Project	IEEE 802.16 Broadband Wireless Access Working Group < http://ieee802.org/16 >	
Title	802.21 Media Independent Handover Function Requirements and Amendments	
Date Submitted	2005-11-09	
Source(s)	<p>Vivek Gupta, Jose Puthenkulam Intel Corporation JF3-206, 2111 NE 25th Avenue, Hillsboro, OR 97124, USA</p> <p>Ronny (Yong-Ho) Kim, Jin Lee LG Electronic Inc. LG R&D Complex, 533 Hogye-1dong, Dongan-gu, Anyang, 431-749, Korea</p>	<p>Voice: 503 712 1754 Fax: 503 264 4230 [mailto:vivek.g.gupta@intel.com]</p> <p>Voice: +82-31-450-1879 Fax: +82-31-450-7912 [mailto:ronnykim@lge.com]</p>
Re:	Call for comment	
Abstract	This contribution proposes requirements and amendments to 802.16g specification for 802.21 Media Independent Handover (MIH) Function.	
Purpose	This document proposes a 802.21 requirements and amendments	
Notice	This document has been prepared to assist IEEE 802.16. It is offered as a basis for discussion and is not binding on the contributing individual(s) or organization(s). The material in this document is subject to change in form and content after further study. The contributor(s) reserve(s) the right to add, amend or withdraw material contained herein.

Requirements an

Figure 4. Illustration of the Network Control and Management System

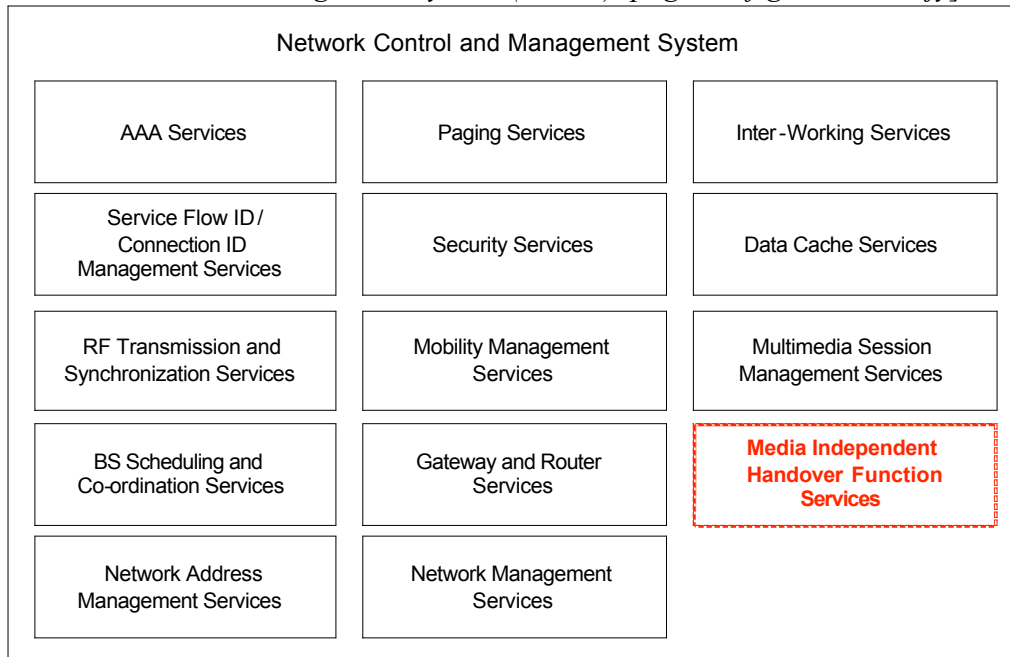
NCMS is required to be extended to support MIH event services, command services, and information services. When NCMS in terminal or BS interfaces with MIH Function, NCMS may provide means for MIH Function to interface with management plane in MS or BS.

In order for NCMS to support MIH function, extend NCMS functionality.

[In 14.4.1.1 Network Control and Management System (NCMS), page 13, figure 4, modify]:

Figure 5 – 802.16g Protocol Architecture Model

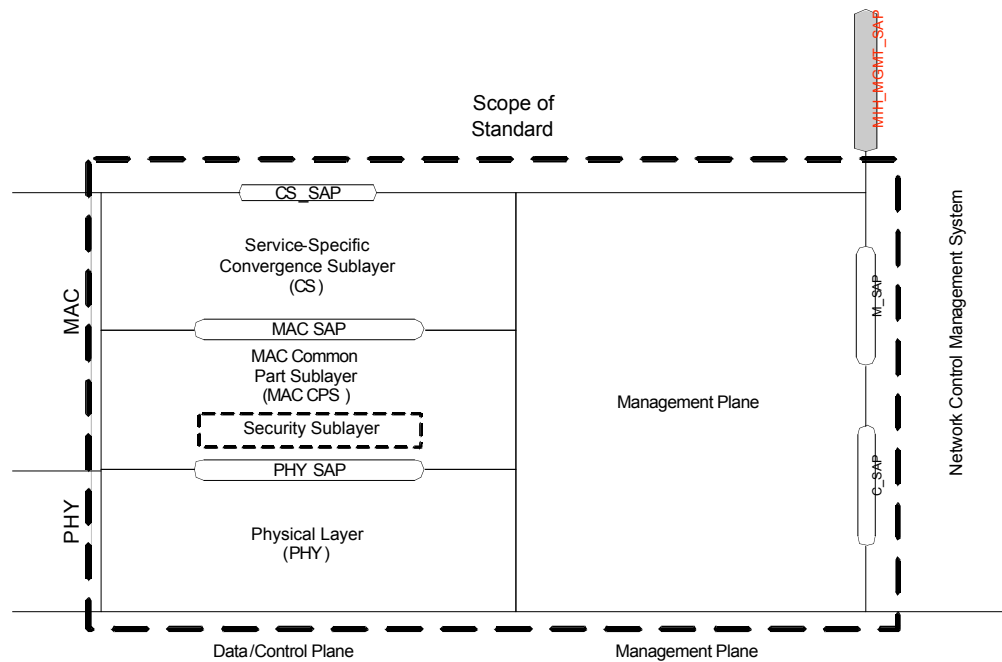
In order for NCMS to support FS/MS, interface between FS/MS and NCMS should be described.

[In 14.4.1.2 BS and NCMS Interface, page 13, line 47, modify]:

This interface is a set of Service Access Points (SAP) and is represented and in the Figure 5 below. It is decomposed in to two parts **for interface with NCMS**: the Management SAP used for Management primitives alone and the Control SAP is used for Control plane primitives that to support handovers, security context management, radio resource management, and low power operations (such as Idle mode and paging functions). The primary goal of such an interface is to ensure protocol separation.

Management plane or NCMS in FS/MS or BS has a interface with Media Independent Handover (MIH) Function. MIH_MGMT_SAP defines the interface between NCMS and the MIH Function.

Figure xxx: The use of primitives to generate MAC management messages

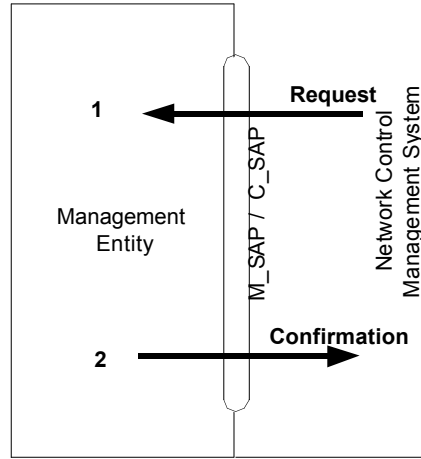
The use of these primitives to provide peer communication is shown in Figure 3. The use of primitive can be divided into two categories. The first category is with interaction with the peer entity, and the second category is primitive exchange within local stack. The initial request for service from a higher layer through NCMS is provided by the “Request” primitive. The request triggers to generate appropriate MAC management message and the MAC management message is sent across the air interface to the peer MAC. Upon reception of the MAC management message over the air interface, corresponding “Indication” primitive is generated to inform NCMS of the request; When the response for the request is made from the higher layer, the response is delivered through the NCMS by the “Response” primitive. The response triggers to generate appropriate response MAC management message and this message is transmitted over the air interface to the originating side. Upon reception of the response MAC management message over the air interface, corresponding “Confirmation” primitive is generated and delivered to higher layer via NCMS.

Primitives exchange for the unidirectional MAC management messages, which don’t require response messages, such as MOB_HOIND, MOB_TRF-IND, and for the local management of the MAC state machine, is shown in Fig. 3, (2). The initial request for service from a higher layer through NCMS is provided by the “Request” primitive. The request triggers either to generate appropriate unidirectional MAC management message or MAC state change depending on the primitive. “Confirmation” primitive conveying the result of the request is delivered to the higher layer through NCMS.

Figure xxx: The use of Ranging Primitives

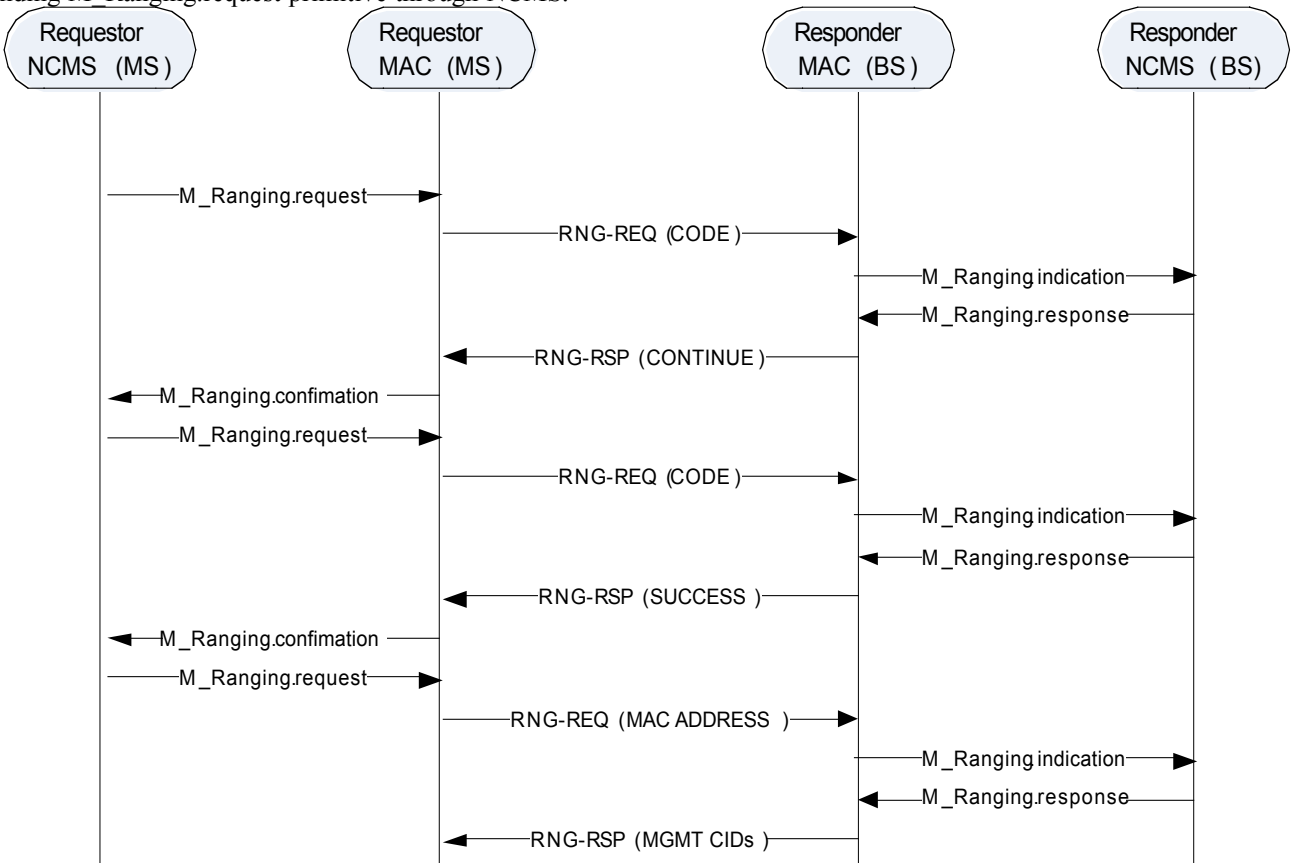
Upper layers can control ranging procedure with these primitives. Upper layers shall commence 802.16 link setup procedure by sending M_Ranging.request primitive through NCMS.

Fig 4: The use of Registration Primitives

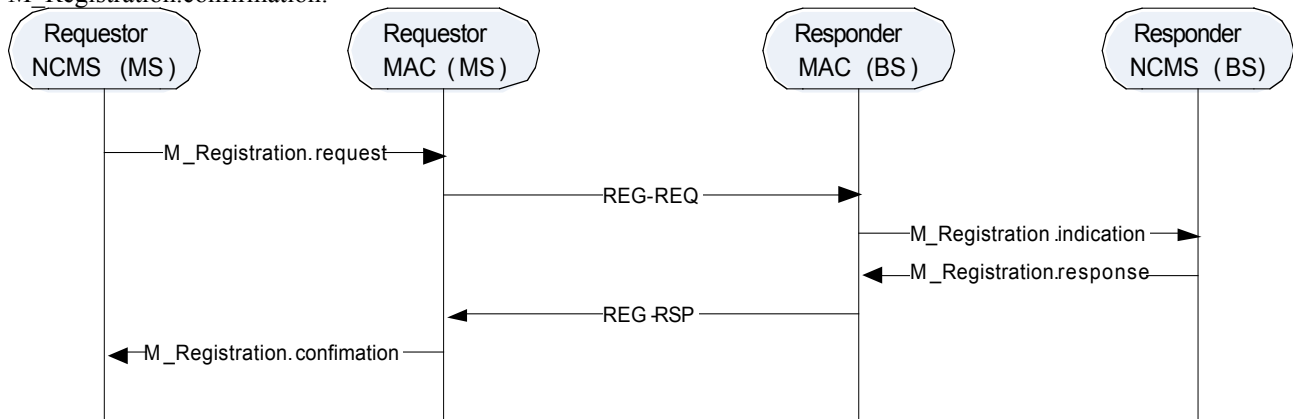
Upper layers can control registration procedure with these primitives. Upper layers are notified of link setup by M_Registration.confirmation.

Fig 4: The use of Neighbor Advertisement Indication Primitives

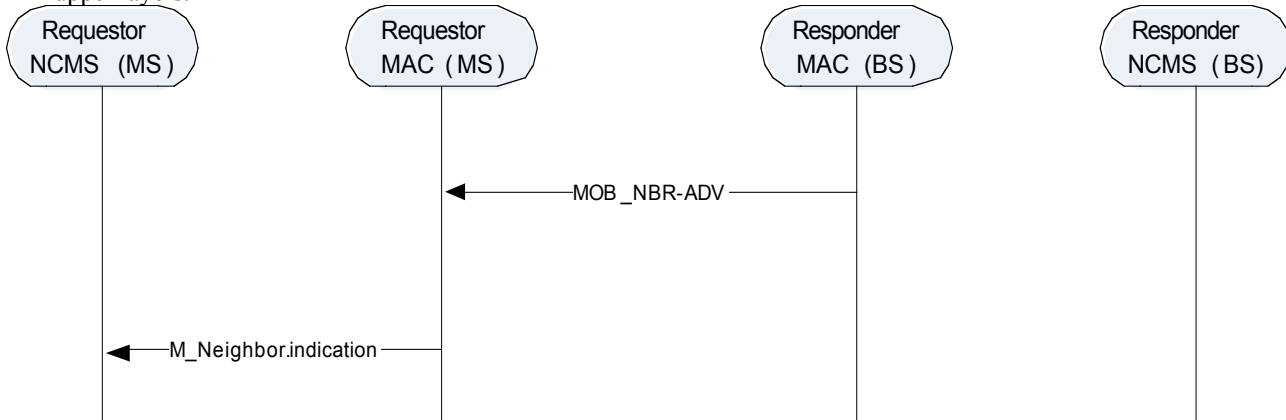
When 802.16 MAC receives neighbor advertisement (MOB_NBR-ADV), this primitive is used to deliver the information to upper layers.

Fig 5: The use of Scan Scheduling Primitives

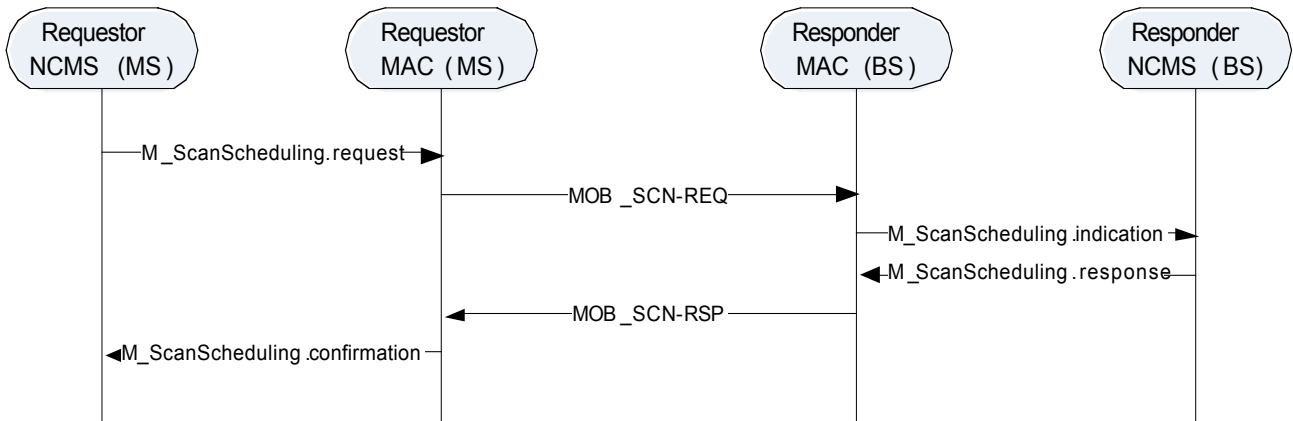
Upper layers can schedule scanning period with BS. During scanning period BS may buffer downlink traffic to the mobile terminal.

Fig 6: The use of Scanning Primitives

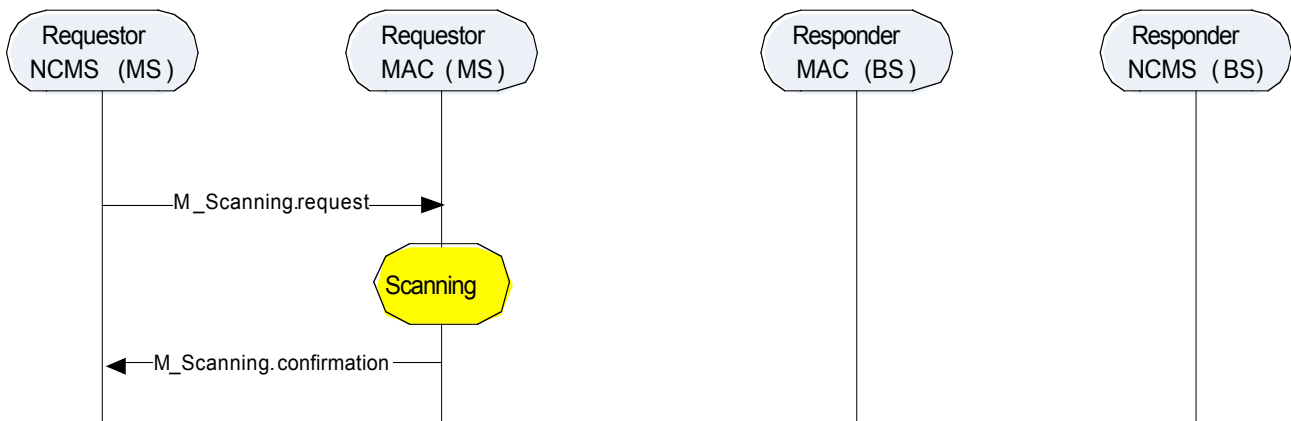
Upper layers can command autonomous scanning with these primitives.

Figure 6. Use of Scan Report Primitives

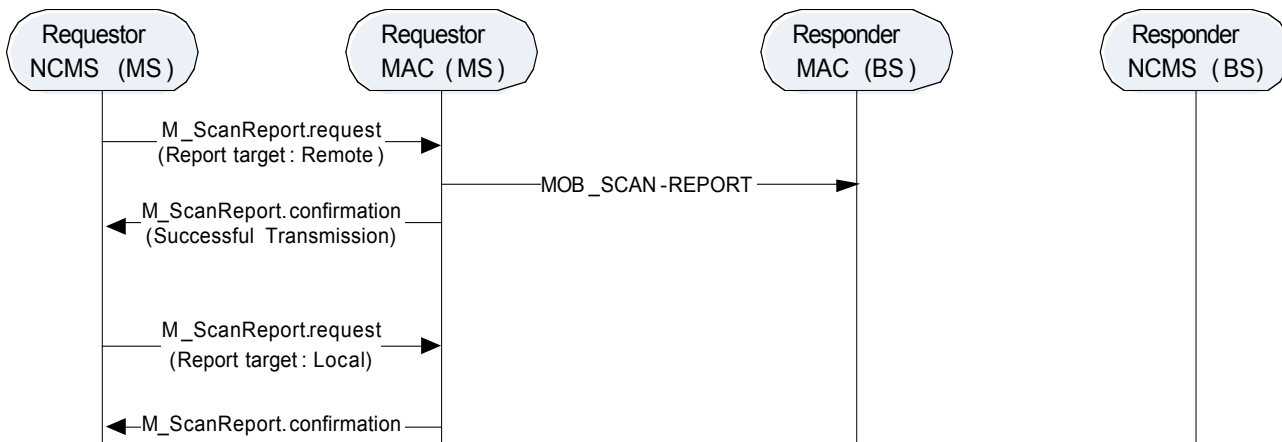
Usage scenario is shown in Figure 6. Only primitives delivered by NCMS are shown. Delivery of the primitives shall be based on the pre-registration procedure between upper layer management entities and NCMS.

Scan report can be made remotely to the BS or locally to the upper layer entity depending on the report target value in M_ScanReport.request.

Fig 7: The use of Handover Primitives

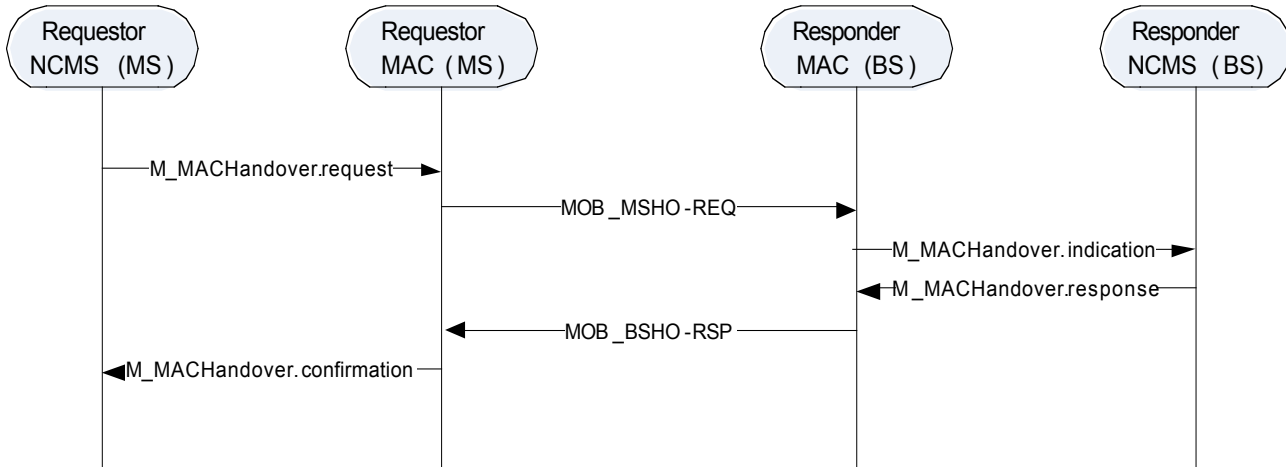
Upper layers can control handover procedure by using these primitives.

Fig 8: The use of Handover Indication Primitives

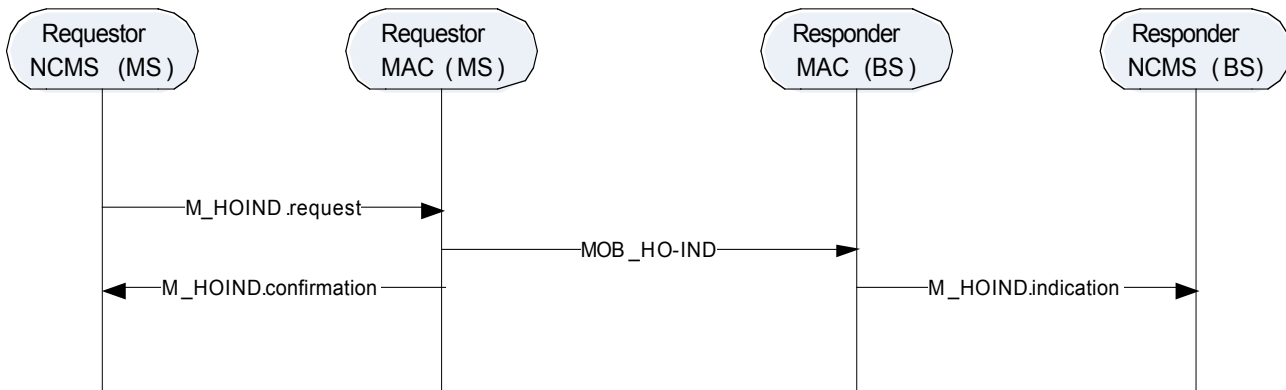
An MS transmits a MOB_HO-IND message for final indication that is about performing a HO.
